MEMORANDUM

RE: **RECONSIDERATION OF Application Nos. NW-PRB1-2684 and NW-PDP-2685 – Rezoning and Preliminary Development Plan (PDP)**

Allenbrand-Drews & Associates, applicants, and Kar Choi and Ying Yau Tse, landowners, request rezoning from RUR, Rural District, to PRB-1, Planned Rural Retail Business District and Preliminary Development Plan approval, for a commercial center including four commercial buildings to be known as Prairie West.

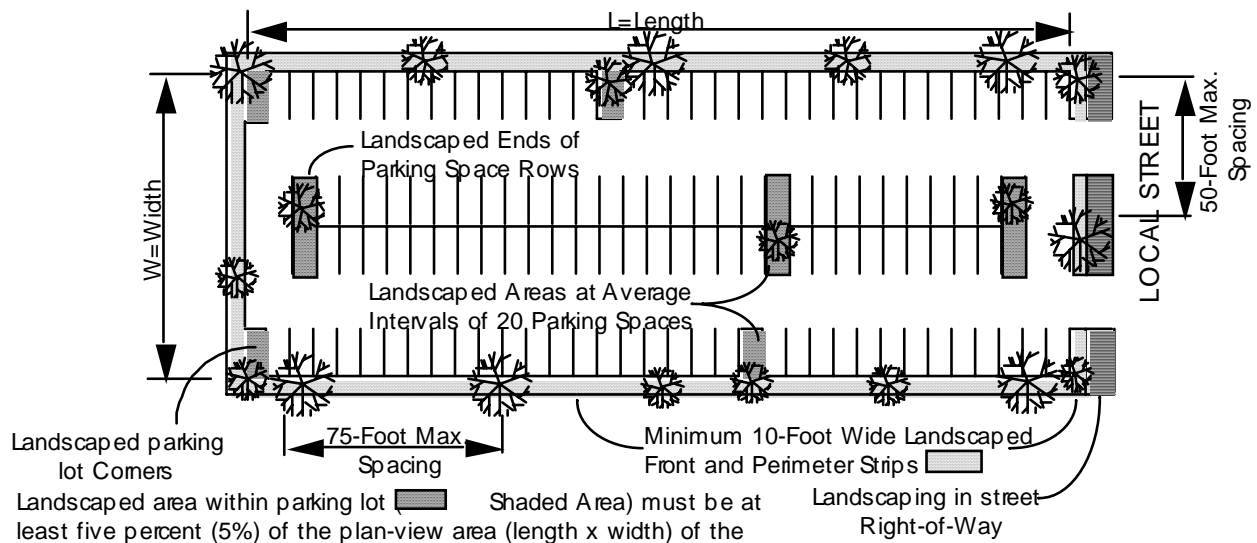
- b. *Interior Landscaping for parking lots with 20 or more parking spaces:*
 - 1). *At least 5% of the total plan-view area of the parking lot shall be landscaped.*
 - 2). *At least one tree shall be provided for each 300 square feet of that 5% of the total plan-view area (length times width) of the parking lot.*
 - 3). *The ends of parking space rows and the parking lot corner areas shall be landscaped. For example purposes, see drawing below.*
 - 4). *Landscaped areas at least equivalent to the area of one parking space shall be provided within parking space rows at average intervals of 20 parking spaces. For example purposes, see drawing below.*

The proposed PDP shows landscaping around the property perimeter, but no interior parking lot landscaping. To meet minimum requirements, the proposed PDP must be revised to show at least the minimum required amount of parking lot interior landscaping.

- f. Interior Landscaping for parking lots.
 - 1). At least 5% of the total plan-view area of the parking lot shall be landscaped.

- 2). At least one tree shall be provided for each 300 square feet of that 5% of the total plan-view area (length times width) of the parking lot.
 - 3). The ends of parking space rows and the parking lot corner areas shall be landscaped.

- 4). Landscaped areas at least equivalent to the area of one parking space shall be provided within parking space rows at average intervals of 20 parking spaces.
